Subject Addendum to Work Plan for Historical Water Supply Well Reconnaissance – Well #1; Area 1A, Topock Compressor Station, Needles, California

Date 06 October, 2022

DATE: September 12, 2022

**SUBJECT: Work Plan for Historical Water Supply Well Reconnaissance
Well #1; Area 1A, Topock Compressor Station, Needles, California
(EPA ID NO. CAT080011729)**

GSU Figure 1
Western view of Topock Compressor Station in 1951

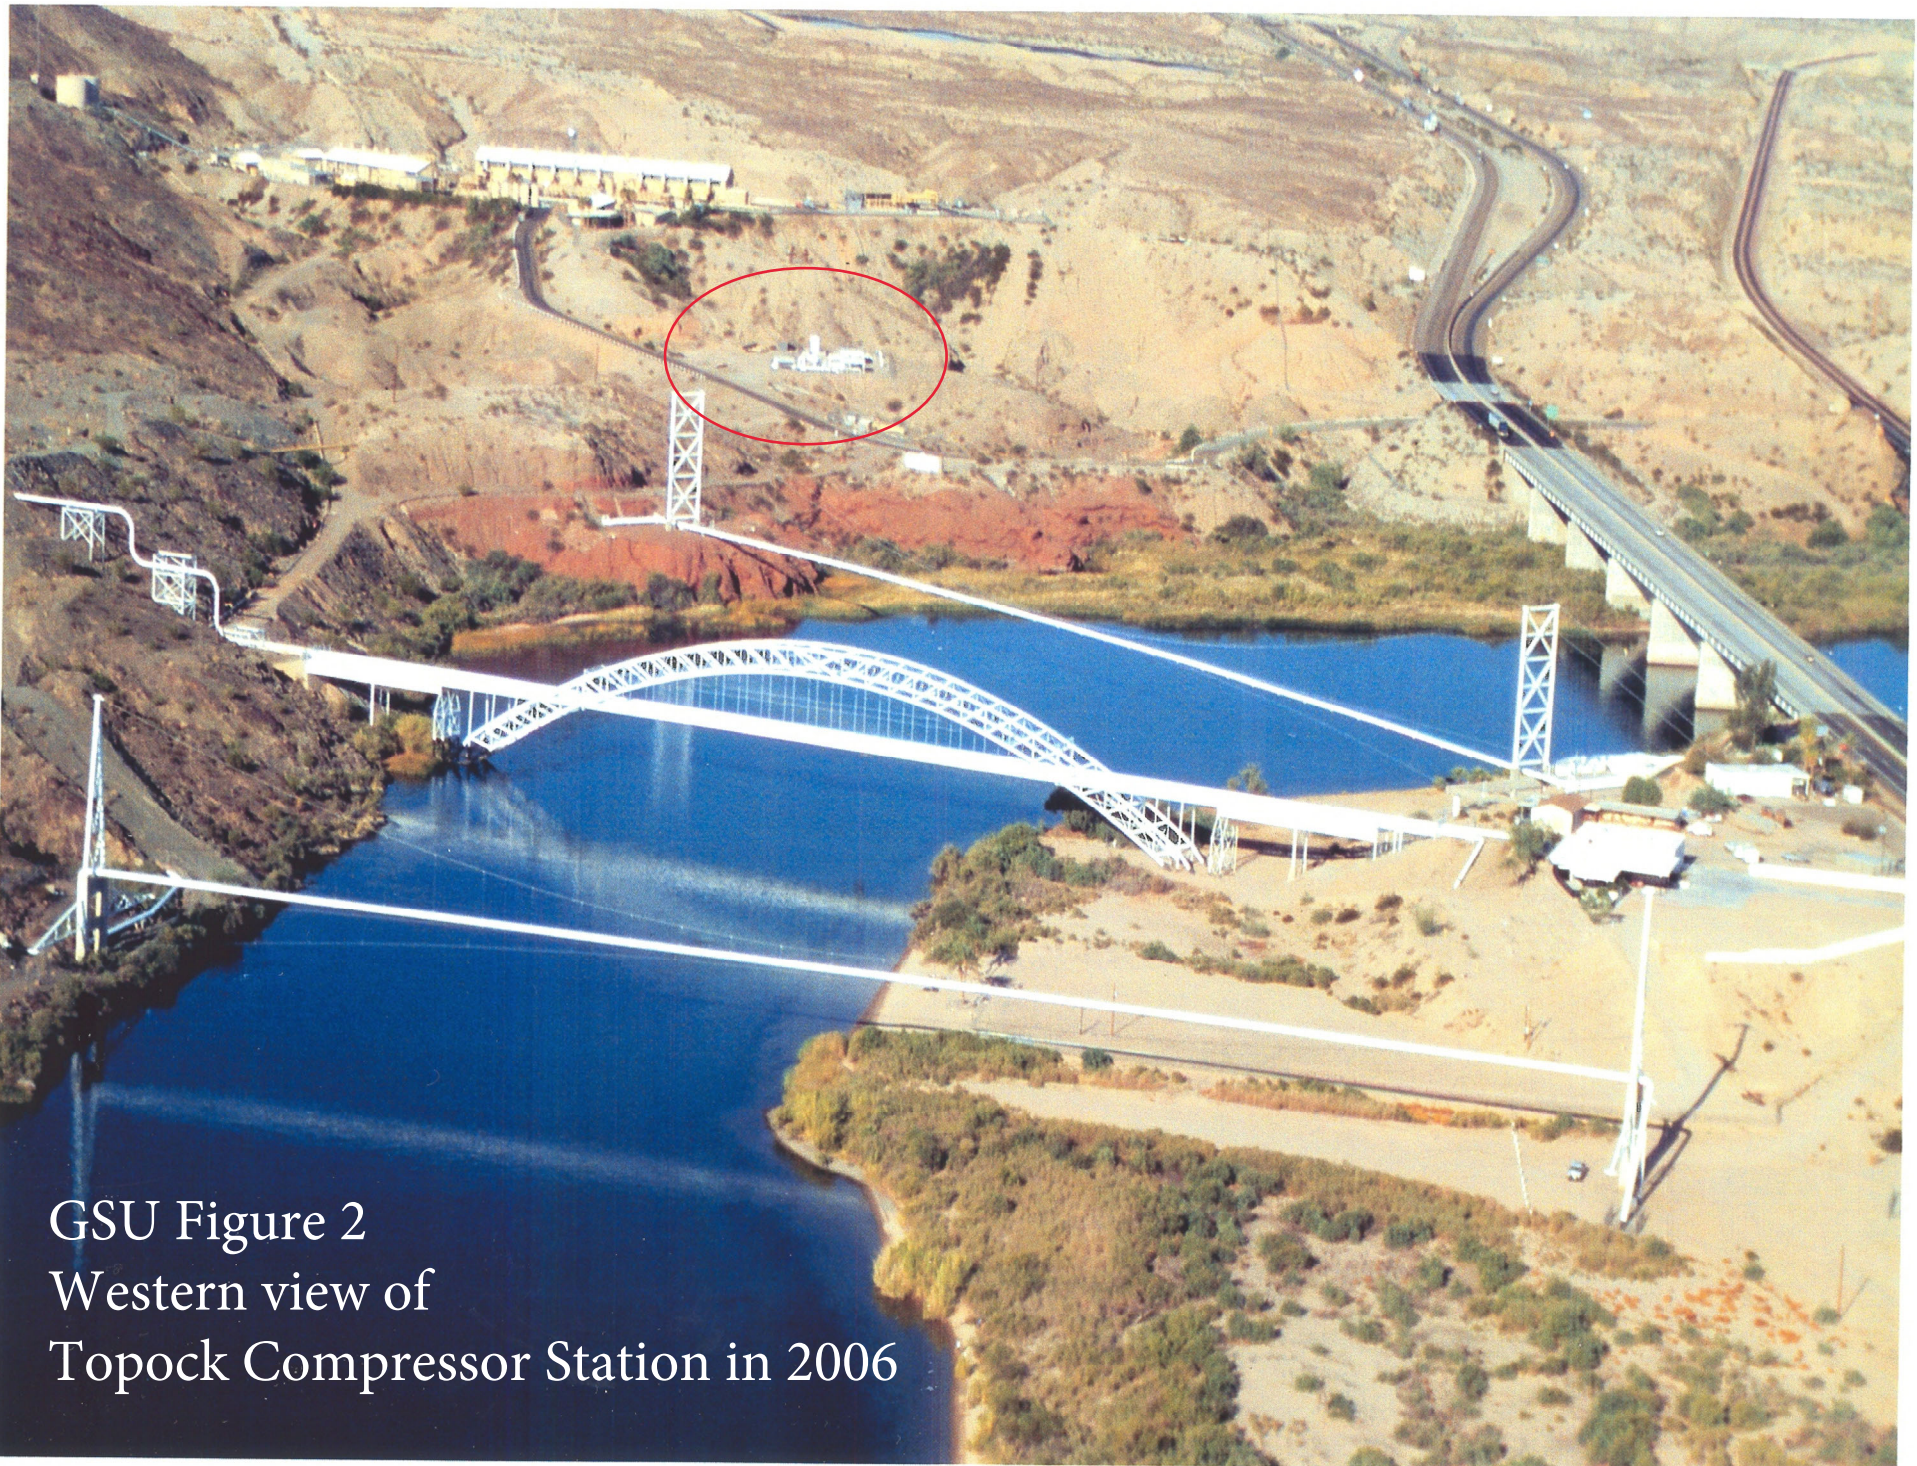
2. Proposed Survey Area 1A, Paragraph 1, Page 1: The Proposed Survey Area (Area 1A) to be evaluated is identified on Figures 1 and 2 of the Work Plan and excludes the Transwestern area. The Transwestern area is referred to as the "Transwestern Disturbed Area" on Figures 1 and 2. It should be noted that both the Transwestern and Area 1A areas are quite disturbed and both occur due to significant earthwork including removal of prominent hills. While Attachment 1, prepared by DTSC's GSU, estimates that Well #1 is outside the Transwestern fence line, Figure 2 of the Work Plan (Attachment 2) shows that Well #1 plots within or adjacent to the Transwestern fence line. Therefore, geophysical surveys should also include the area within the Transwestern fence. GSU Figure 1 shows the station in 1951. The

Transwestern and Area 1A area can be seen with grading that has occurred on the southern portion of the bench similar to Figure 2 Work Plan drawings. Figure 2 drawings and the 1951 aerial photograph also shows the large hill on the Transwestern Bench area that was later removed to construct the Transwestern facility as can be seen in the October 2006 aerial (GSU Figure 2). The yellow highlighted area on Attachment 2 is supposed to represent the southern flat area within the Transwestern yard that would have been available to drill a well circa 1950.

Specific Comment 2: This Work Plan excludes the area within the Transwestern metering station fence line as it is an active facility that PG&E does not control. This comment is noted, and should implementation of this Work Plan not yield the location of Well #1 (exploratory well), the area identified by DTSC will be addressed as part of the April 25, 2019 work plan.
